PCI-SIG ENGINEERING CHANGE NOTIFICATION

TITLE:	Enhanced DPC (eDPC)
DATE:	Introduced: April 4, 2012; Last Updated: November 14, 2012 Final PWG Approval November 15, 2012
AFFECTED DOCUMENTS:	PCI Express Base Specification Revision 3.0 Downstream Port Containment (DPC) ECN
SPONSORS:	Joe Cowan, HP; Mahesh Wagh, Intel

Figure 6-3: Pseudo Logic Diagram for Error Message Controls

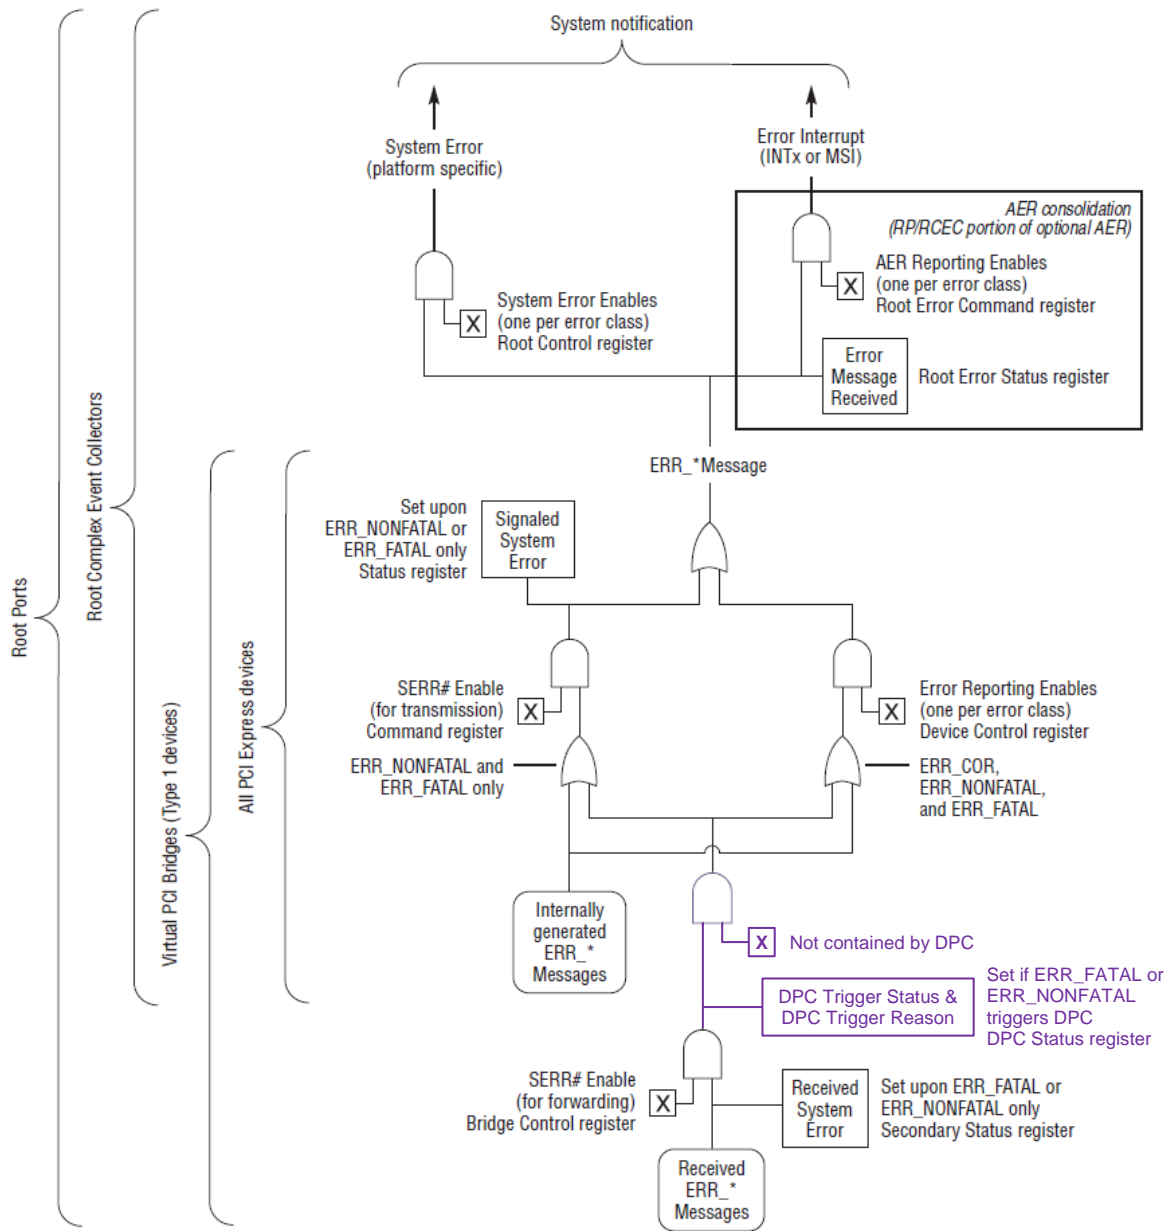
The following modification to Figure 6-3 was made by an erratum against the original Downstream Port Containment ECN, and is shown here for reference:

Figure 7-34: Uncorrectable Error Status Register

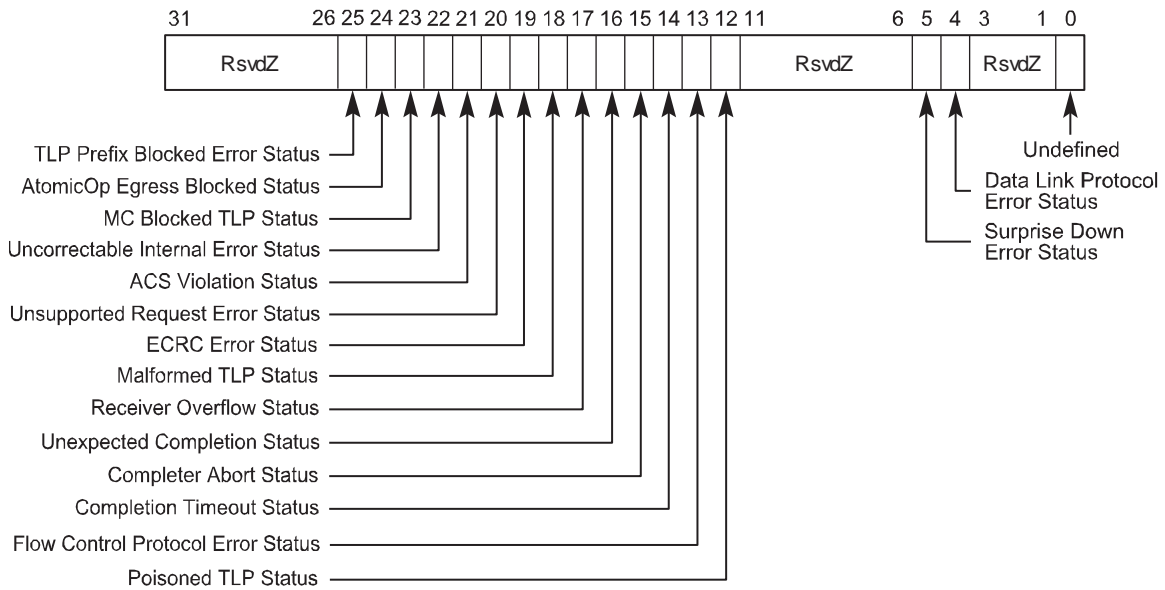
Note to Editor: modify the above figure to indicate the bit that is defined in the table below.

Bit Location	Register Description	Attributes	Default
...
12	Poisoned TLP Received Status	RW1CS	0b
...
26	Poisoned TLP Egress Blocked Status (Optional)	RW1CS	0b

Figure 7-35: Uncorrectable Error Mask Register

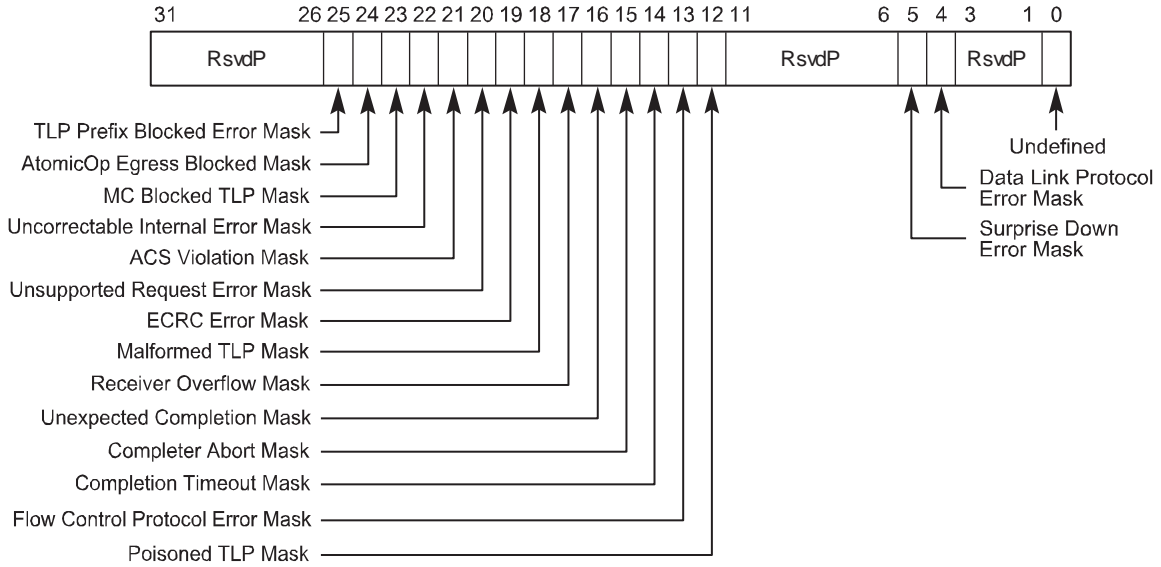
Note to Editor: modify the above figure to indicate the bit that is defined in the table below.

Bit Location	Register Description	Attributes	Default
...
12	Poisoned TLP Received Mask	RWS	0b
...
26	Poisoned TLP Egress Blocked Mask (Optional)	RWS	1b

Figure 7-36: Uncorrectable Error Severity Register

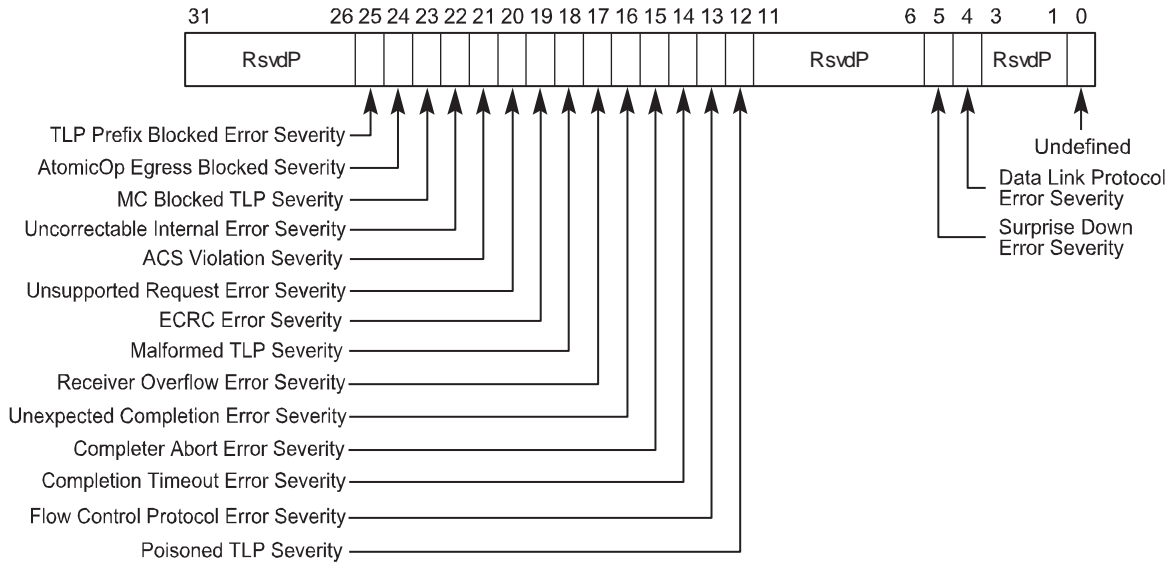
Note to Editor: modify the above figure to indicate the bit that is defined in the table below.

Bit Location	Register Description	Attributes	Default
...
12	Poisoned TLP Received Severity	RWS	0b
...
26	Poisoned TLP Egress Blocked Severity (Optional)	RWS	0b

Figure 7-xx: RP PIO Header Log Register

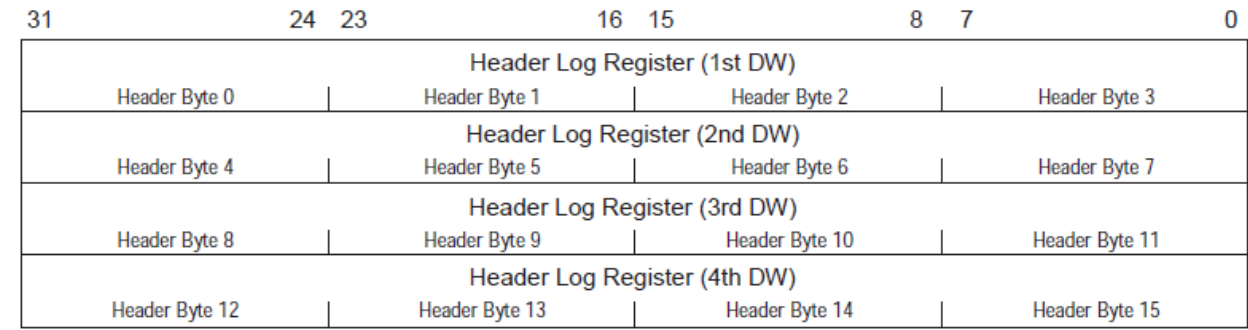
Note to Editor: modify the above figure to indicate the RP PIO Header Log register.
